SH24G/Stapleton Rd.  
El Paso County

### LSC Responses to CDOT Comments

RE: Waterbury Filings Nos.1 and 2 PUD PP - PUDSP215

# LSC Responses to Deviation 1 Redline Comments

Deviation Exhibit 2 **4**

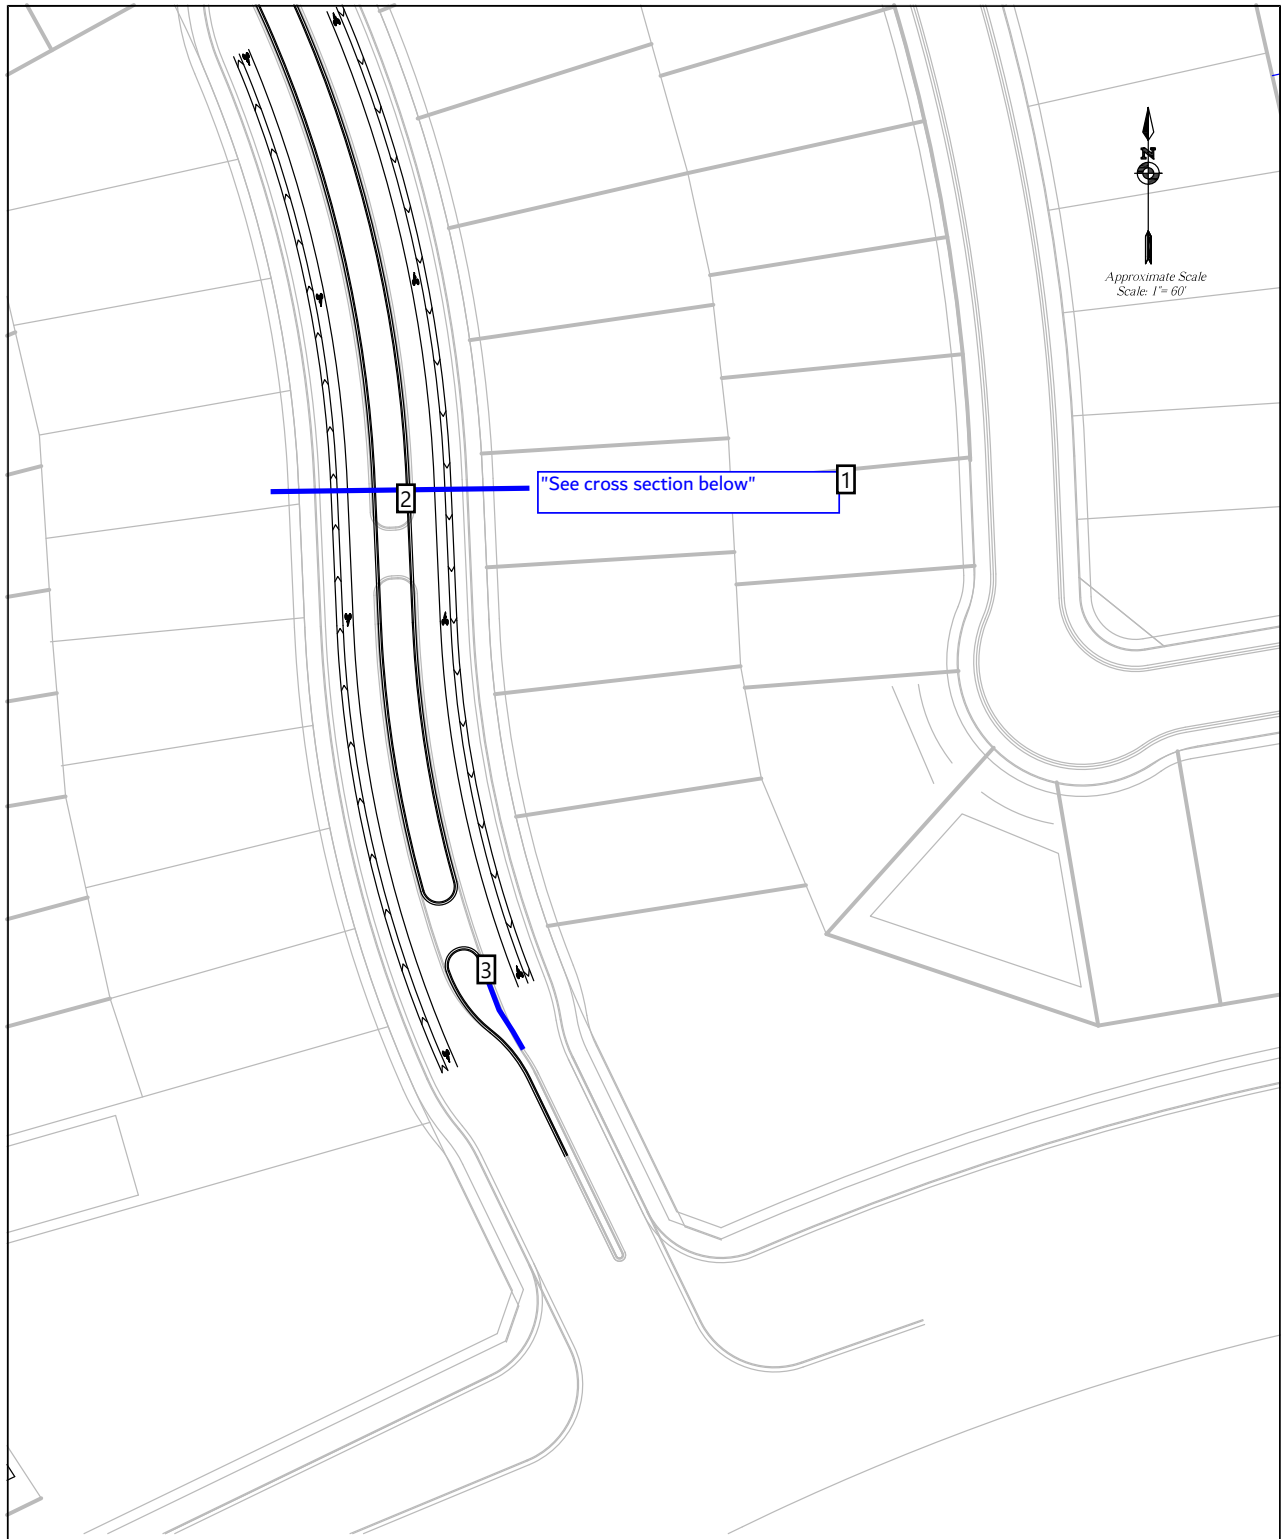
State that Water quality will be provided (verify)

Author: lscja      Subject: Sticky Note      Date: 7/20/2022 11:58:18 AM  
LSC Response: Added as requested.
